THE OLD RECTORY, MERE, WILTSHIRE, BA12 6DS

HERITAGE STATEMENT ADDENDUM 2
(PL/2026/03798)

August 2026

Figure 11. Illustration of proposed south elevation. Note proposed dining room window providing balance and visual harmony within existing fenestration.

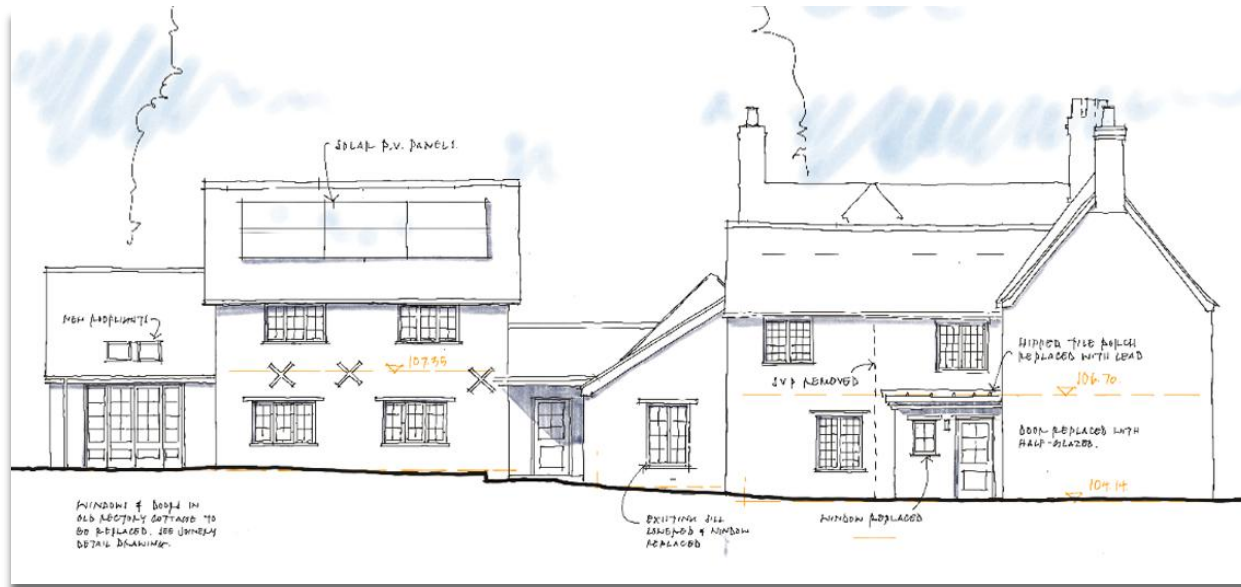
4.2 The Applicant's seek consent to remove the existing timber framed window to the south elevation, which is a later insert into a historic door opening as evidenced by stone infill below. This element of the scheme intends to lower the window sill to create a heritage appropriate window seat which will allow for the increased observation and enjoyment of the setting to the south from within the dwelling throughout the seasons. The modest increase in size (Fig.11) will require the removal of some historic, but not original fabric (stone).

4.3 This latest iteration of the scheme has evolved to provide a sympathetic and pragmatic solution for the existing ground-floor window, enabling its retention and continued use within the dwelling with which it is historically associated, thereby avoiding its complete removal from the building. Fortuitously, the existing first-floor bathroom window opening is of similar proportions to the ground-floor window, requiring only a minimal reduction in width of approximately 50mm. This can be readily accommodated through the introduction of slightly wider framing to either side of the relocated window, without materially altering the proportions of the existing opening. The current first-floor bathroom window is a modern, economically constructed faux-leaded casement dating from 2023 (Figs.9 and 10), incorporating applied (stick on) faux leadwork that is physically and visually incongruous with the character and architectural quality of The Old Rectory. Its replacement with the existing ground-floor window, which will be carefully repaired and conserved where necessary prior to relocation, provides an opportunity to retain, conserve and repurpose existing fabric within the listed building, rather than allowing its permanent loss. The approach therefore represents a positive conservation-led amendment, securing the continued functional use of the window while also improving the architectural coherence of the first-floor fenestration.

4.4 The existing opening does not represent an unaltered element of the historic elevation and has itself undergone previous alteration in response to the changing requirements of the building and its occupants. Whilst this earlier intervention does not establish a precedent for further change, it demonstrates that this part of the elevation has evolved historically and that the existing arrangement is not fundamental to an understanding of the original architectural composition of The Old Rectory. The proposed alteration would continue this established process of carefully managed adaptation, whilst remaining limited in its physical extent.

4.4 cont. The enlarged opening will be fitted with a high-quality timber-framed glazed unit, appropriately detailed to correspond with the established fenestration of the south elevation. The resulting opening will therefore remain compatible with the proportions, materials and architectural language of the listed building and will not appear visually incongruous or undermine the overall character and coherence of the elevation.
